## ADDENDUM NO. ONE (1)

SIGN-IN SHEET for ITB#6- 2016/2017 GCSC SOFTBALL COMPLEX PROJECT

**PLUMBING FLOOR PLAN - LOCKER ROOM FACILITY**  
SCALE: 1/4" = 1'-0"

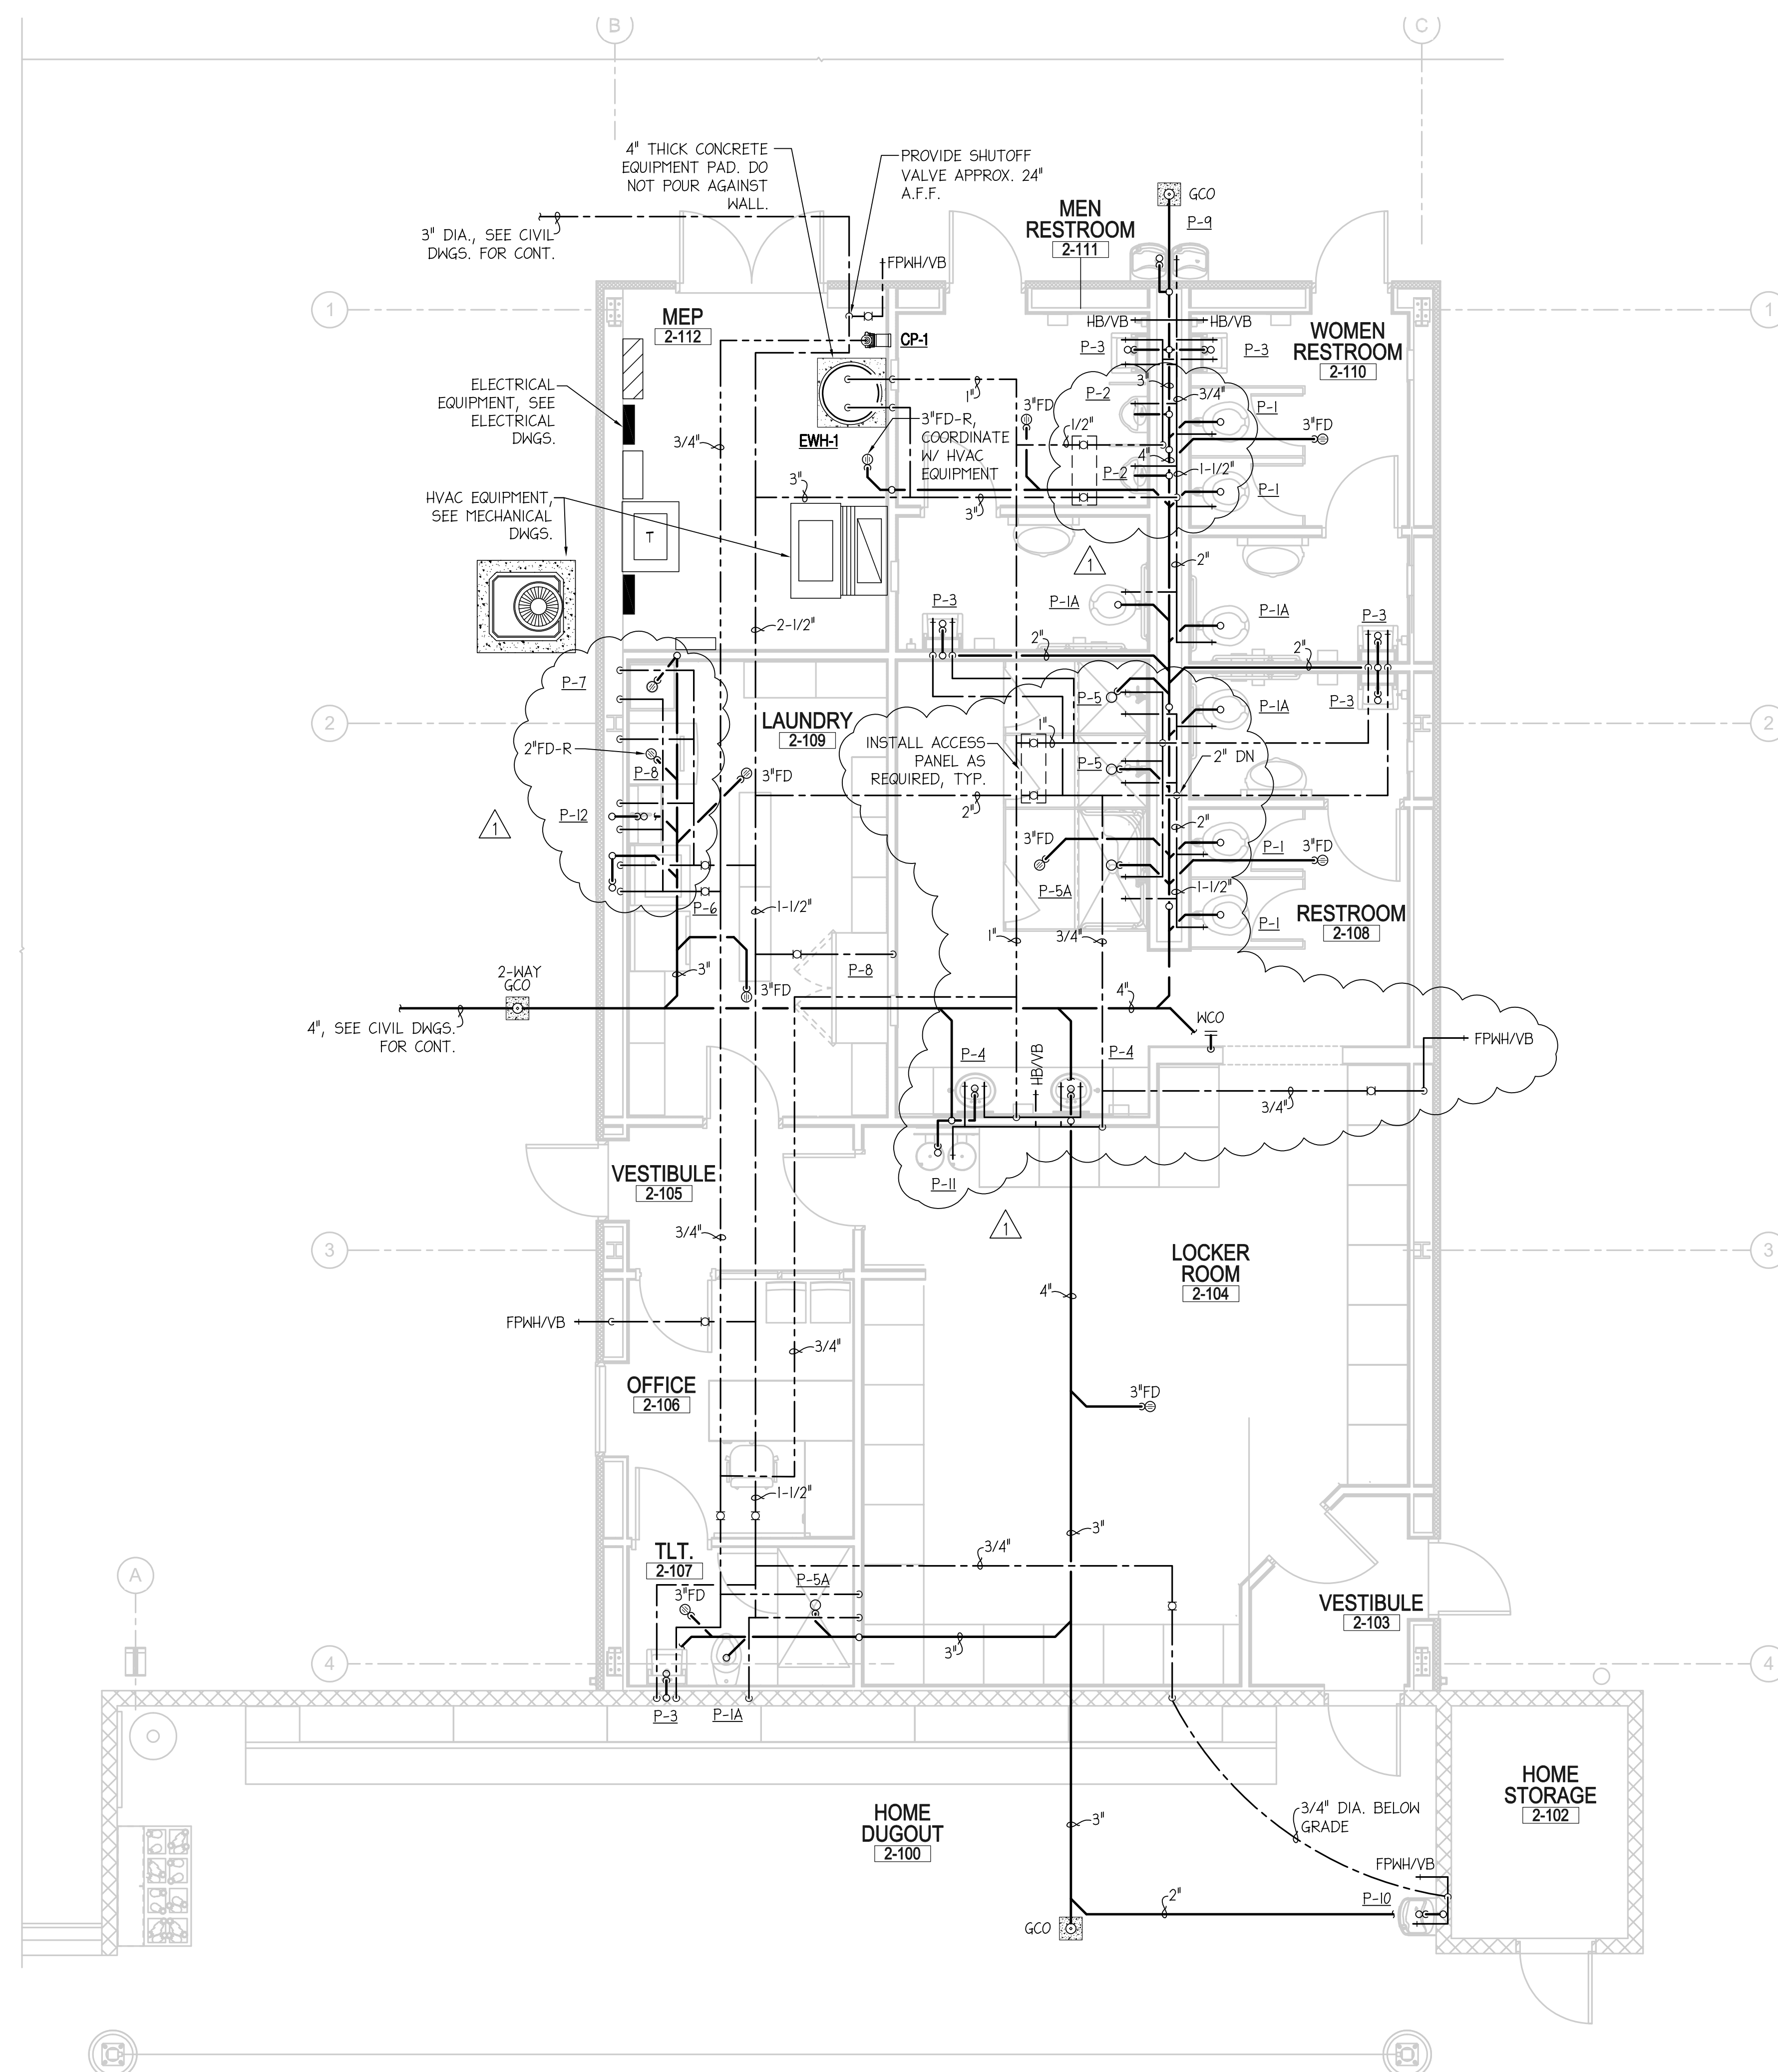
Item No. 3P: Refer to Drawing Sheet P4, Plumbing - Locker Room Facility:

- a. **ADD** Plumbing fixtures in Locker Room and Laundry.
- b. **ADD** Pipe sizes.
- c. **CHANGE** Pipe routing to exterior hydrant.

**ELECTRICAL SITE PLAN**  
 SCALE: 1" = 20'-0"

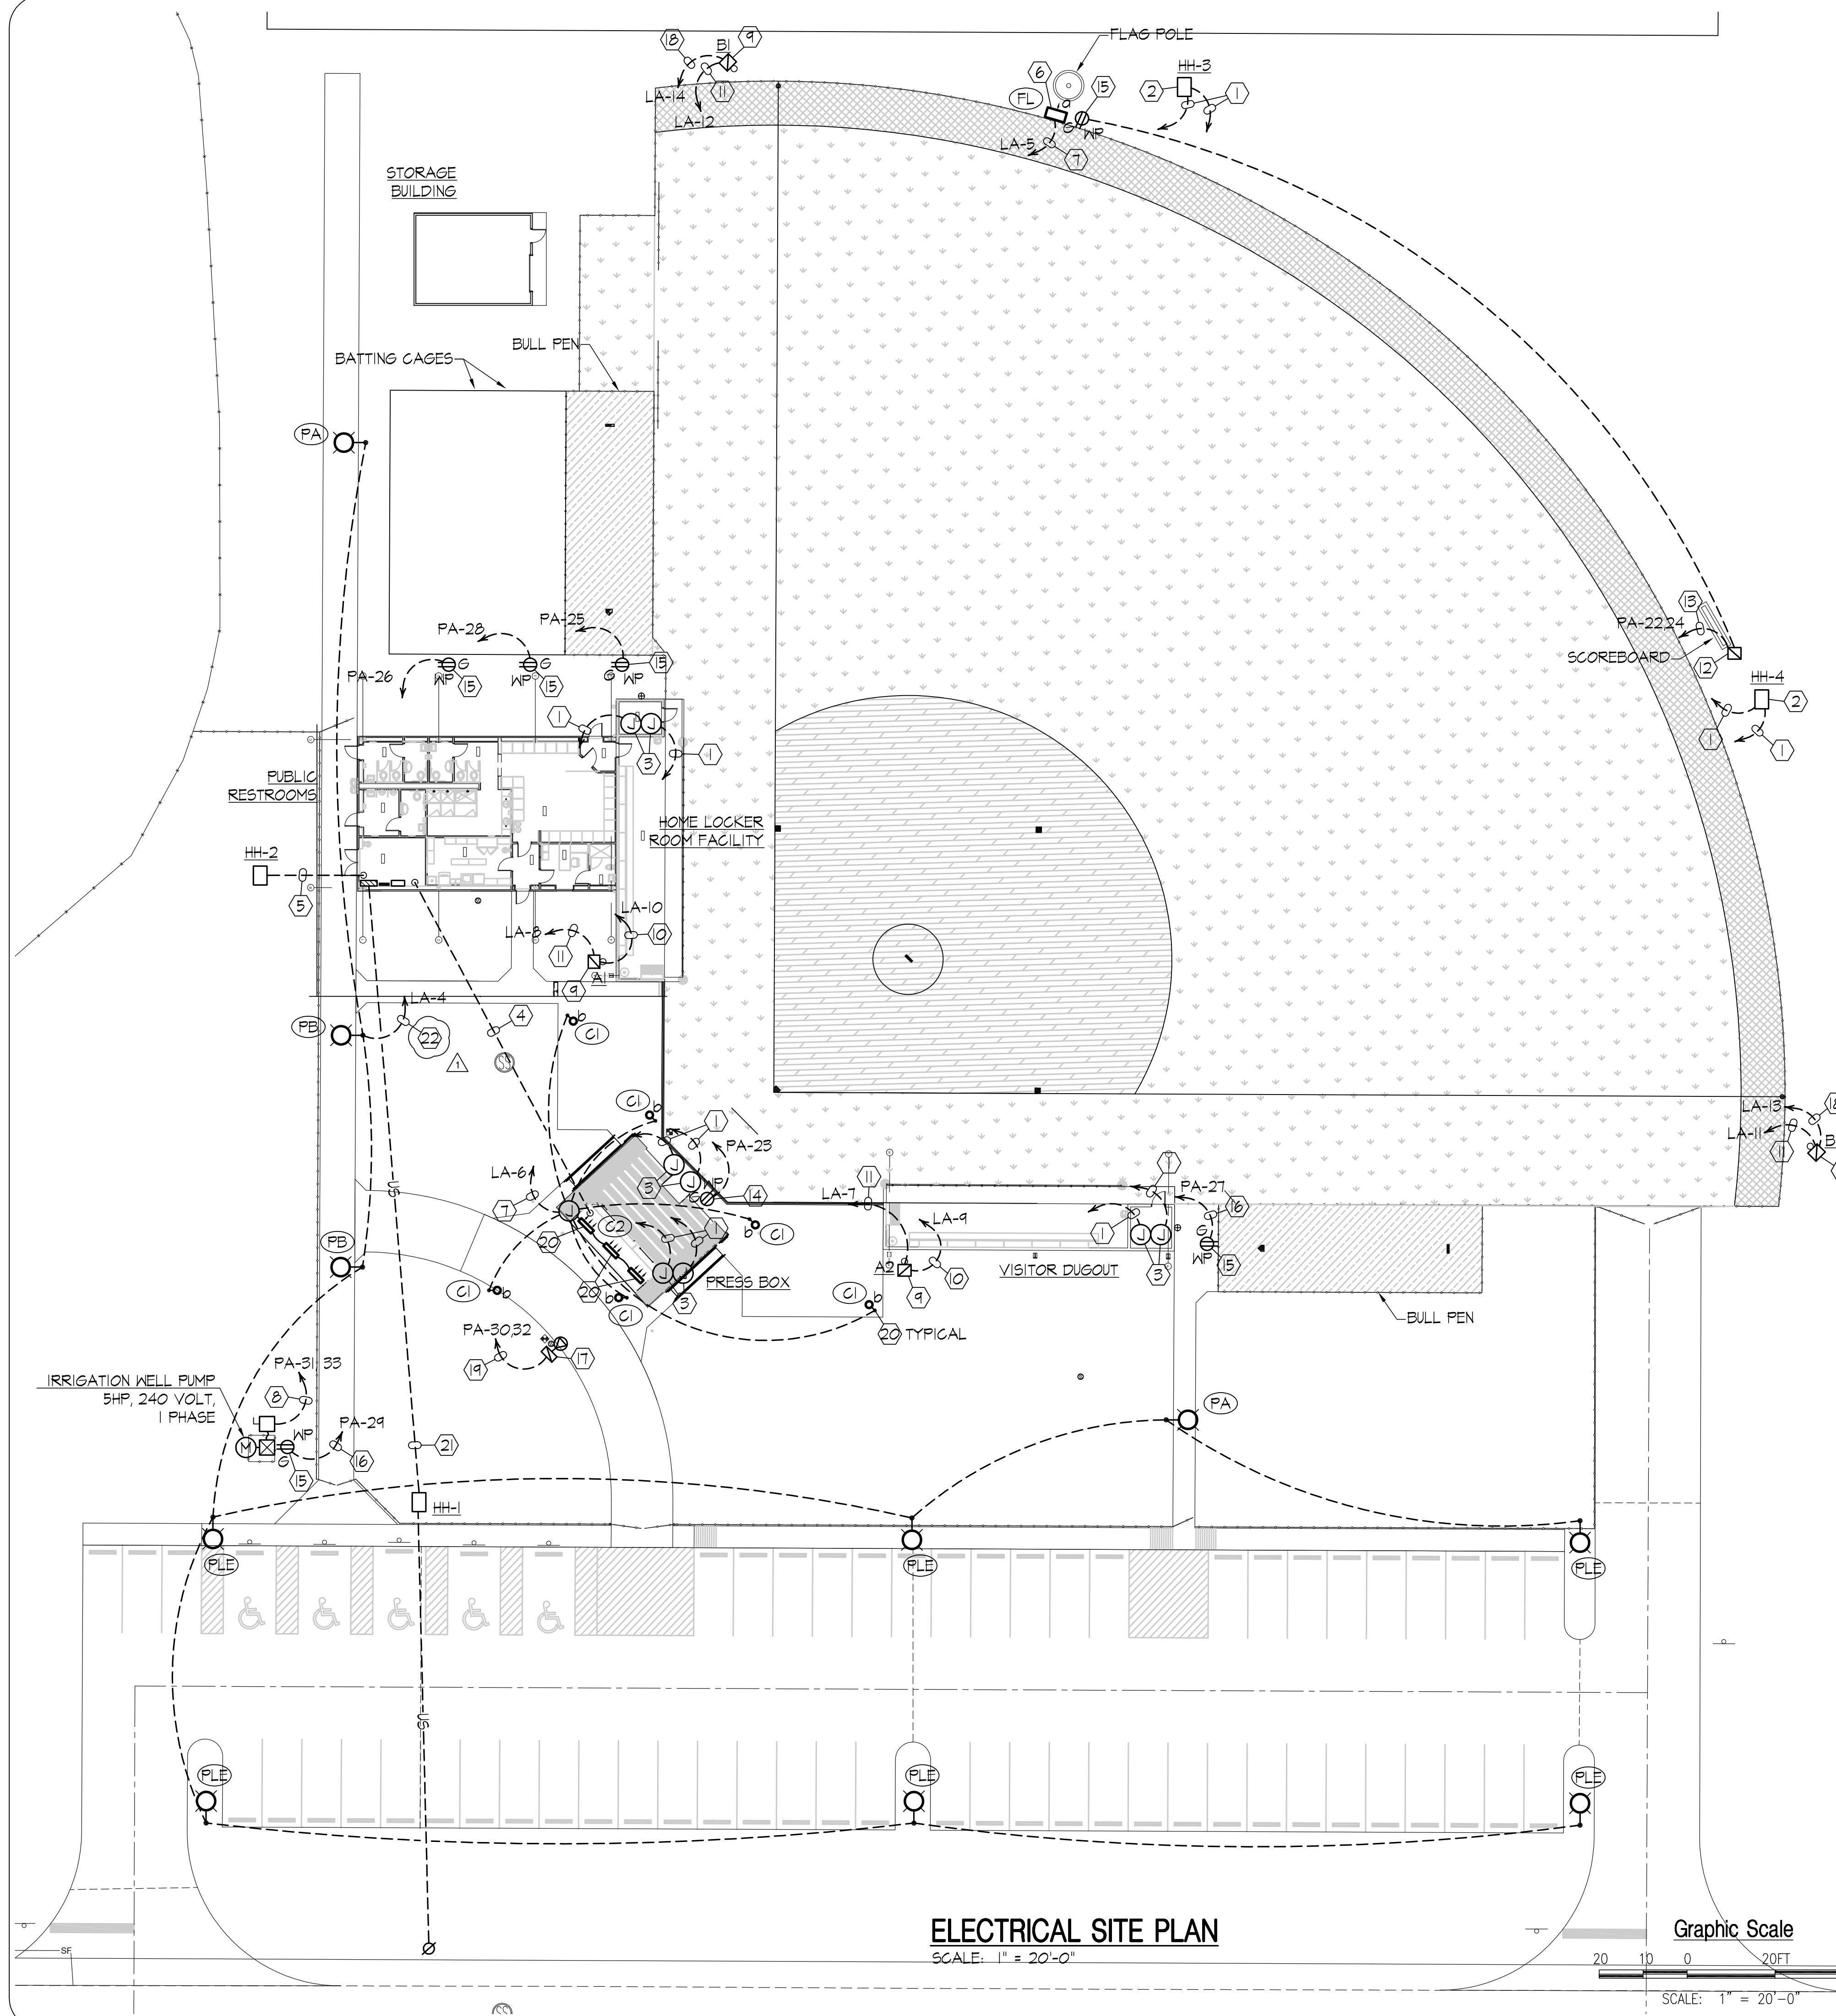
Item No. 1E: Refer to Drawing Sheet E1, Electrical Site Plan:

- a. **CHANGE** Key Note Number to circuit LA-4.
- b. **ADD** Key Note Number 22
- c. **CHANGE** relay marks/designators for flag pole light, canopy lighting and parking lot lighting.
